REGULAR MEETING OF THE WEST BRANCH PLANNING COMMISSION TO BE HELD AT THE WEST BRANCH CITY HALL, 121 N. FOURTH ST. ON TUESDAY, MAY 14, 2024, BEGINNING AT 6:00 PM

Zoning Administrator notes for AuSable Valley Mental Health Pavilion, zoning plan ZP24-05

Zoning Administrator review for permit ZP24-06, Wausau Building Supply Company

RE: Wausau Site Plan Comments

THIS PLAN IS FOR AN OPEN
AIR PAVILION FOR:
ASABLE VALLEY
COMMUNITY MENTAL
HEALTH AUTHORITY
@ 511 GERRARD, WEST BRANCH MI

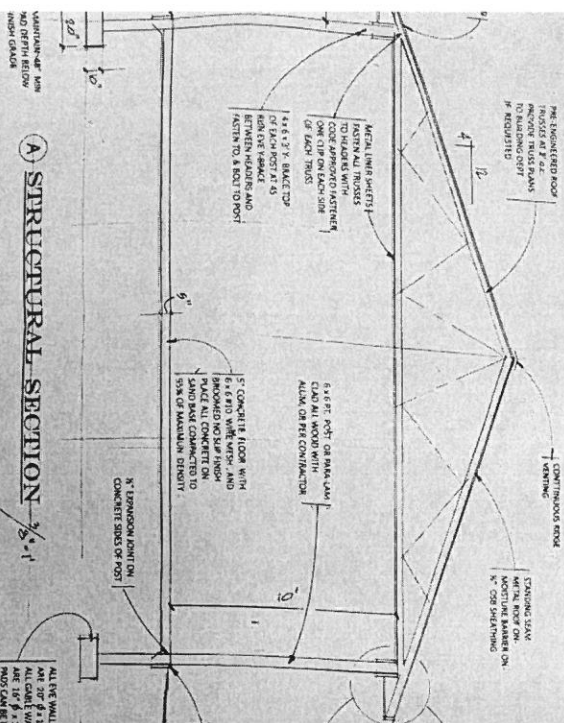
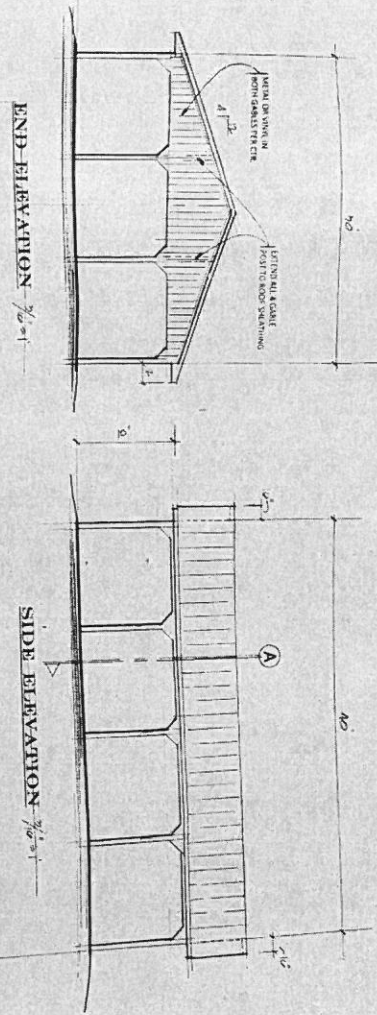
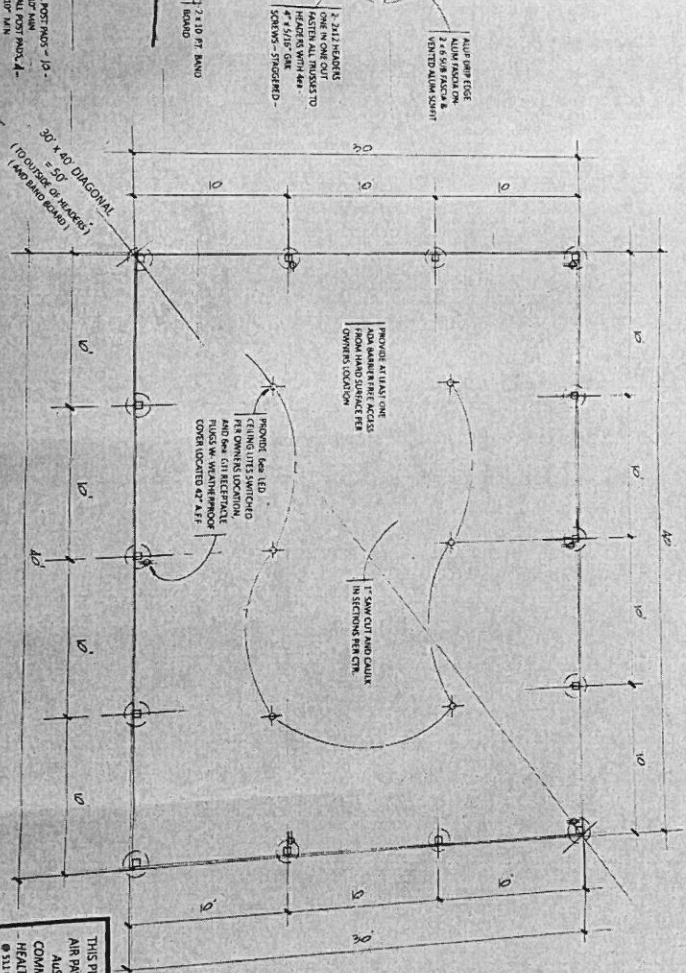
The submitted plans call for the addition of a 30'X40'x10' high covered pavilion which will be used by the employees for an outdoor break and lunch area. As per the definitions in section 2.2 of the zoning ordinance, a covered pavilion would be considered an accessory structure. As noted in table 4.10, accessory buildings and structures are regulated by section 3.10 of the zoning code.

As per section 3.10(b), accessory structures can be located in any yard of the property so the location of the pavilion is allowed.

As per section 3.10(c)(2), accessory structure setbacks are 5' from the side lot lines, 3' from the rear, and a front setback that shall conform to the same setback as the principal structure which in this case is 25'. The proposed plan calls for a front setback of 100', 36' to the rear, and 72' for the closest side setback.

The pavilion is allowed in the zoned district of the property and does match all setback. In addition, because this is just a covered pavilion, it does not pose and additional parking concerns, snow storage, increased traffic, or other zoning issues. I would recommend approval of the plans as submitted.

We would need a motion to approve zoning permit ZP24-05 for AuSable Valley Mental Health as submitted.
